UN#13-057

**Response to NRC Request for Additional Information
RAI 339, Questions 03.08.04-33 and -34, Other Seismic Category I Structures,
Calvert Cliffs Nuclear Power Plant, Unit 3**

RAI No. 339

Question 03.08.04-33

FIGURE 1
CONTOUR PLOTS OF BEARING PRESSURE FOR STATIC LOAD COMBINATIONS

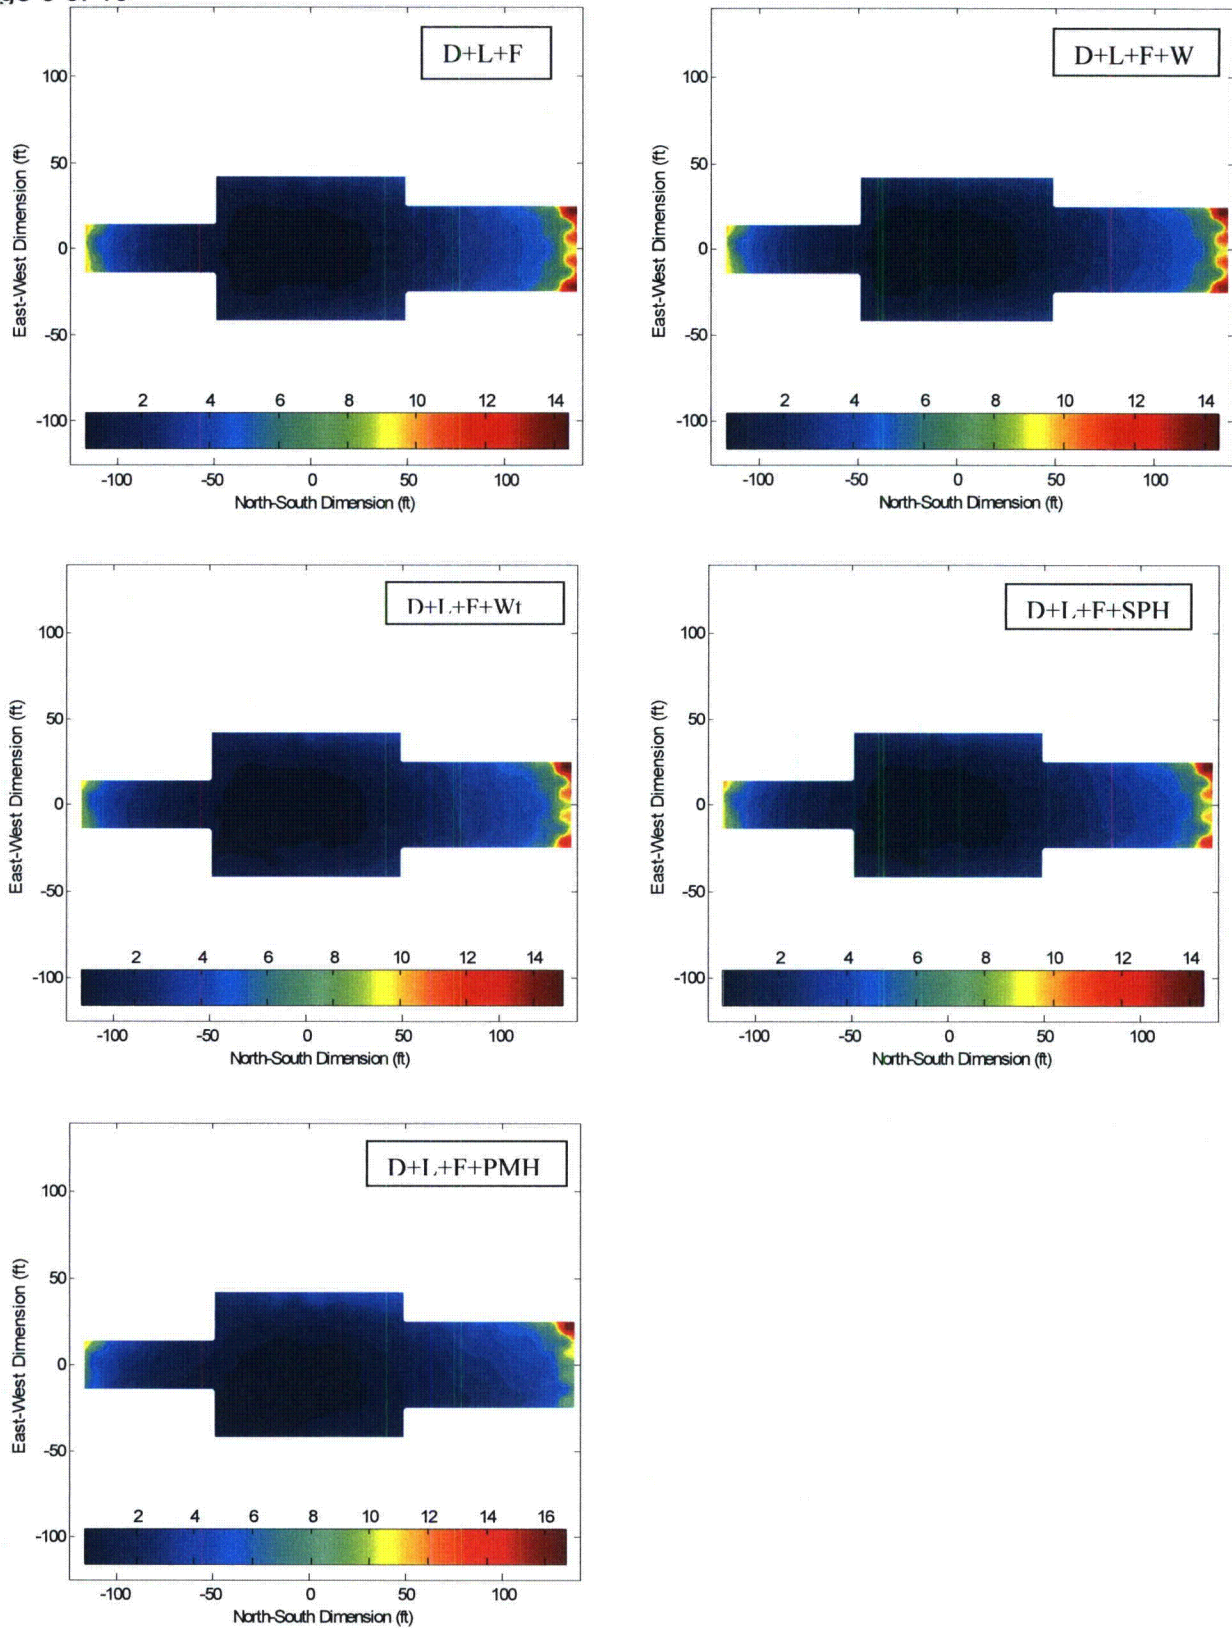
In RAI 301, Question 03.08.04-20, the staff requested that the applicant provide additional information on (1) the exclusion of soil load/lateral earth pressure (H) in the load combinations listed in FSAR Section 3.8.5.3 for bearing pressure evaluation, and (2) the large differences in maximum bearing pressure and bearing capacities between Revision 6 and Revision 7 of the CCNPP Unit 3 FSAR, for the design of the UHS Makeup Water Intake Structure (MWIS).

The staff reviewed the response to RAI 301, Question 03.08.04-20 provided in UniStar Letter UN#11-278 dated November 4, 2011 (ML11314A040). Regarding the bearing pressure calculation, the staff determined that additional information is needed to resolve this RAI item. Since the RAI response indicates that the maximum bearing pressures (static and dynamic) of the CBIS are the maximum of the average pressures under each of the three intake structures (the UHS MWIS, the Forebay and the Circulating Water Makeup Intake Structure), they are not the localized pressures such as the pressures at the toe of the CBIS basemat. The staff requests that the applicant provide the values of the maximum pressures considering all locations of the CBIS basemat design (e.g., maximum pressures that may occur at the toe/edge/corner of the basemat) under worst-case static and dynamic loads. This would represent the localized maximum soil bearing pressure, not the maximum of the average of pressures under each of the three intake structures. Furthermore, explain how these pressures are obtained, e.g., how the soil springs are developed, what the differences are between soil springs for static and dynamic pressures, and how the dynamic pressures from the STAAD Pro FE model analysis compare with the pressures from the SSI analysis, etc. In addition, explain whether the CCNPP Unit 3 bearing capacities provided in Table 3.8-3, as well as those in Table 2.5-65, of the FSAR Revision 7, are the bearing capacities for localized pressure. If they are bearing capacities for localized pressure, explain why the calculated average pressures of the CBIS are compared with the bearing capacities for localized pressure. If they are bearing capacities for average pressure, explain why in Table 2.0-1 of the CCNPP Unit 3 FSAR Revision 7 the CCNPP Unit 3 bearing capacities are compared with the U.S. EPR bearing capacities for localized pressure.

Contour plots of bearing pressure for these load combinations are provided in **Figure 1**. Average bearing pressures across the CBIS basemat and maximum localized pressures for each load combination are provided in **Table 1**.

The contour plots in **Figure 1** indicate that maximum local pressures are concentrated around the Southern edge of the CBIS.

1. Calculation of the resultant foundation load and its corresponding eccentricity that is equivalent to the bearing pressure distribution shown in **Figure 1**.
2. Determination of the reduced area (effective area) due to eccentricity.
3. Computation of the increased average bearing pressure as the ratio of the total vertical load to the reduced area.

Table 1 shows that the average foundation pressures for the entire CBIS area (not the reduced area) are lower than the static bearing capacity, 11.7 ksf, reported in Table 2.5-67 of Rev. 9. The reduced area or effective area calculated based on the eccentricity is at least 65 percent of the overall area. To be conservative, a reduction of 50% in the area of the CBIS is considered in the calculation of the average bearing pressure. The increased average bearing pressures corresponding to the 50 percent reduction in the area are shown in **Table 1** and these are lower than the bearing capacity.

Figure 3.7-22— {CCNPP Unit 3 Strain-Compatible profiles at the Intake Area for CBIS}

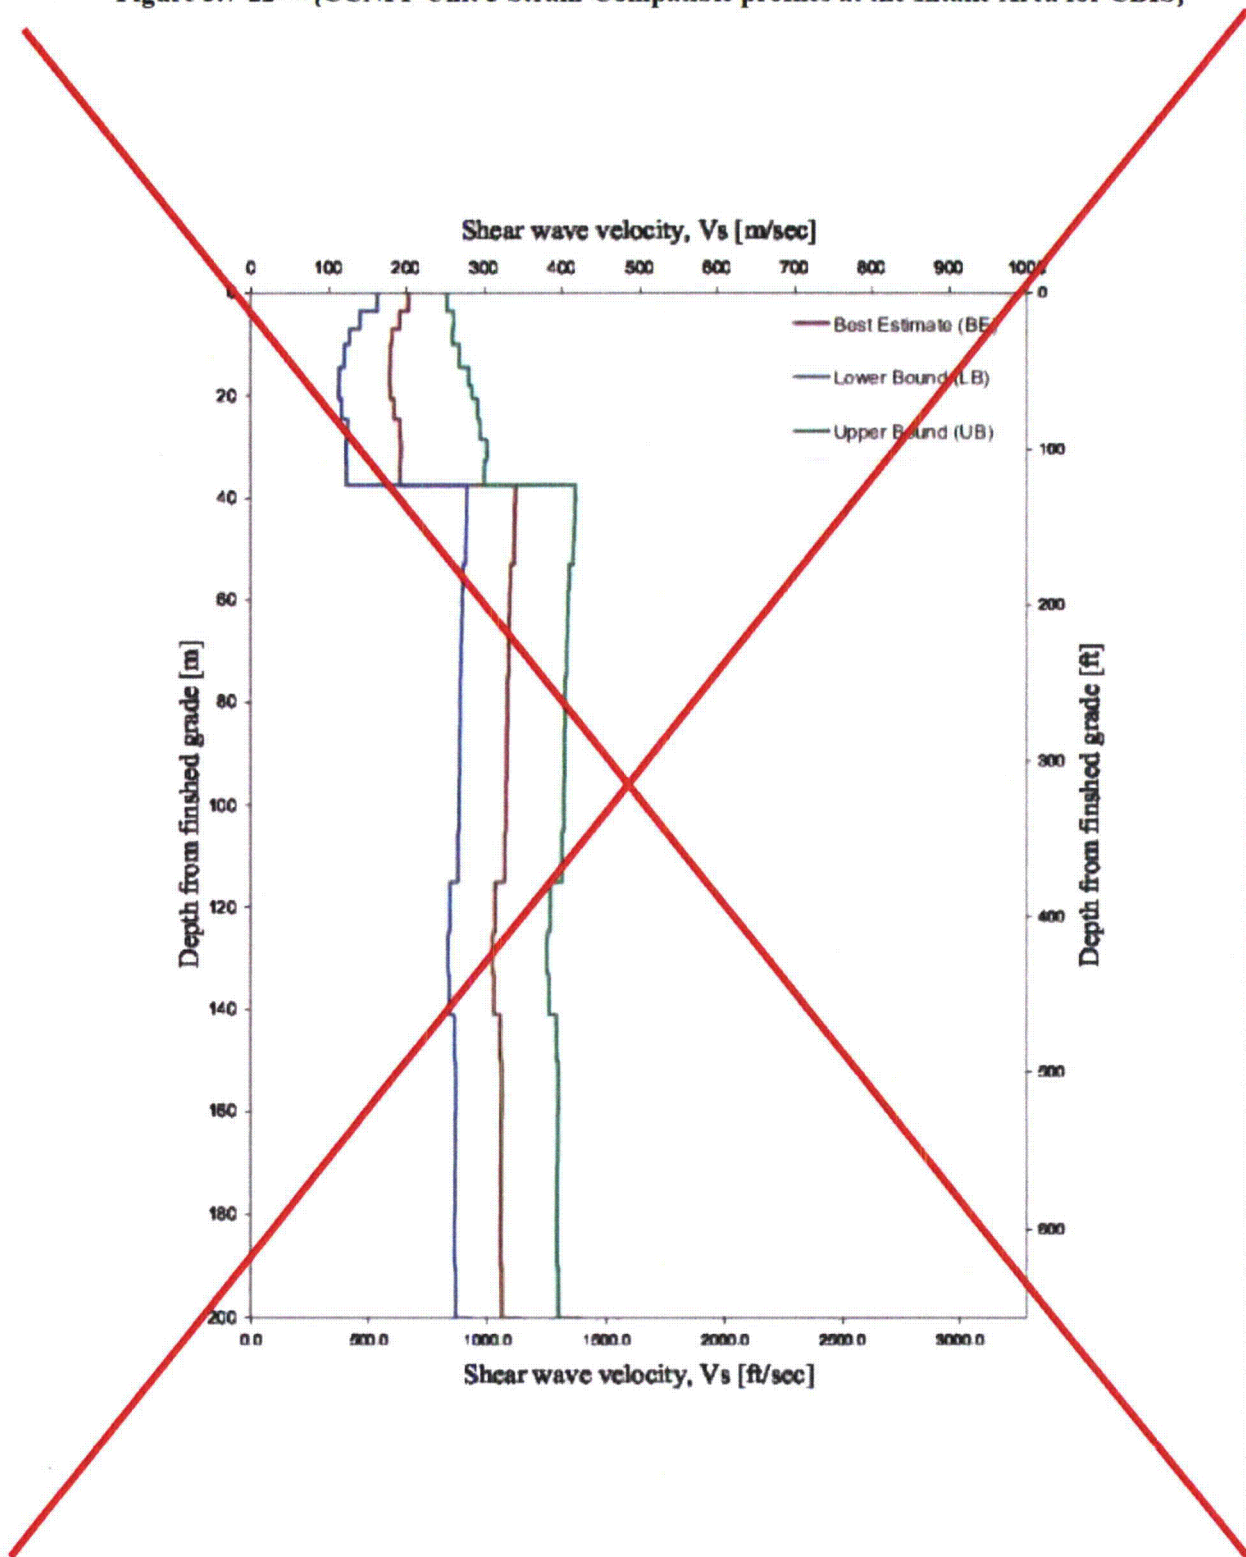
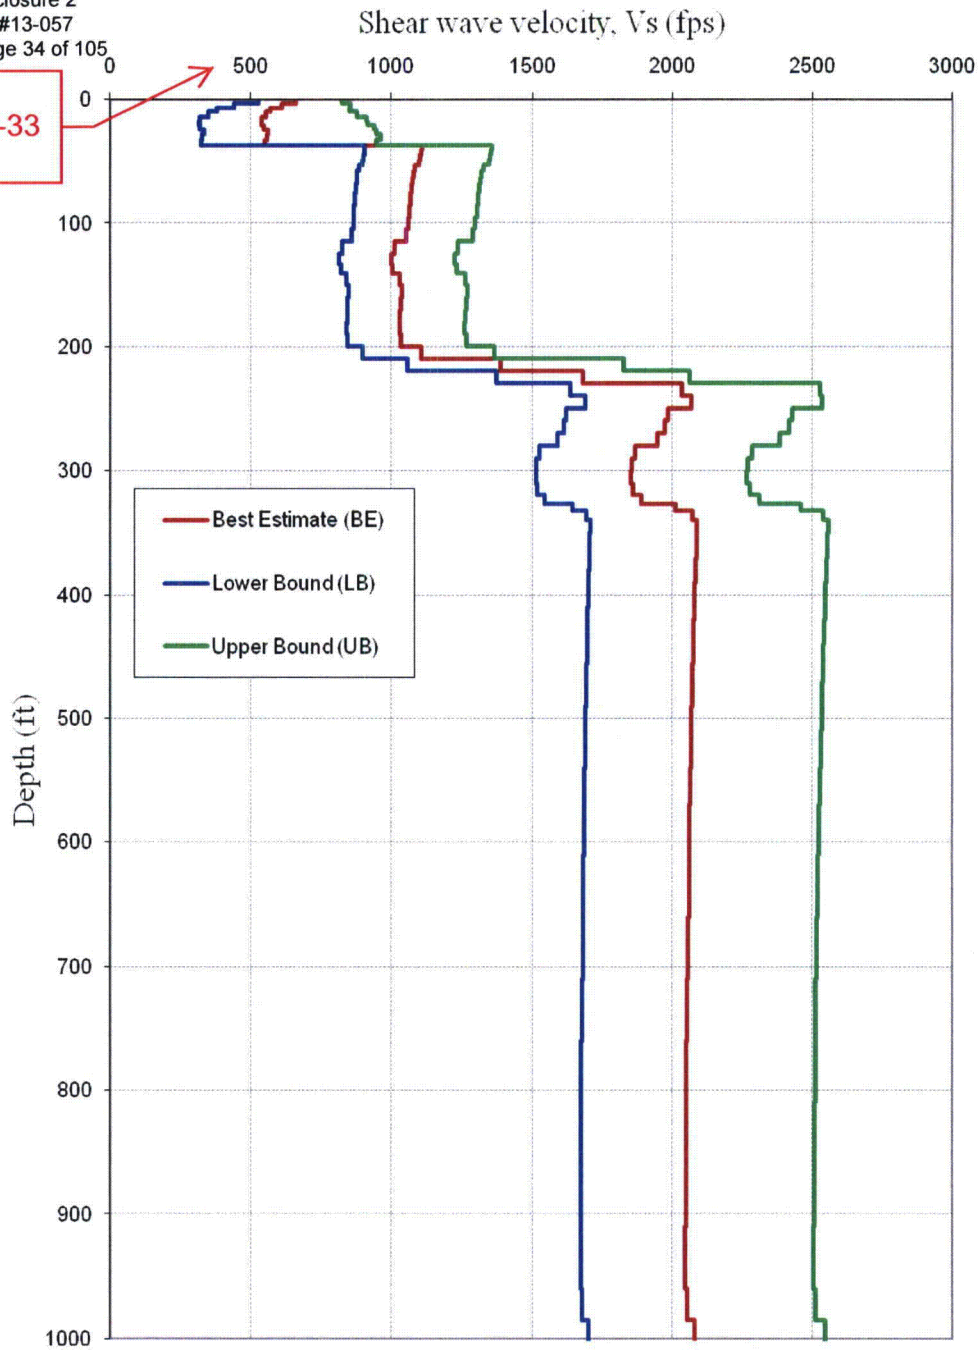
Since the CCNPP method is different than the EPR method, which has been accepted by the staff, provide the technical basis to demonstrate that the CCNPP method to determine the design member forces due to seismic loads for the design and analysis for the Forebay and the UHS MWIS is at least as conservative as the EPR method, or more detailed methods which utilize time history analysis or response spectrum analysis. Guidance on the need for justification for the use of equivalent static load methods for seismic analysis is discussed in SRP Acceptance Criteria 3.7.2.II.1.B.i.

In addition, since CCNPP Unit 3 no longer follows the EPR method to combine accelerations, any CCNPP Unit 3 FSAR reference to the EPR FSAR regarding use of the the EPR methods should be updated, and, a detailed description of the methodology utilized by CCNPP Unit 3 should be included in the applicable section of the CCNPP Unit 3 FSAR.

The supporting media for the seismic analysis of the CBIS in the Intake area are presented in Figure 3.7-22 for the upper ~~656-1000~~ ft (~~200m~~304.8m). The presented soil profiles are site-specific and are strain-compatible with the Site SSE. The development of the Site SSE strain-compatible soil profiles is described in detail in Appendix 3F. The dimensions of the CBIS, including the structural height, are described in Section 3.7.2.3.2.
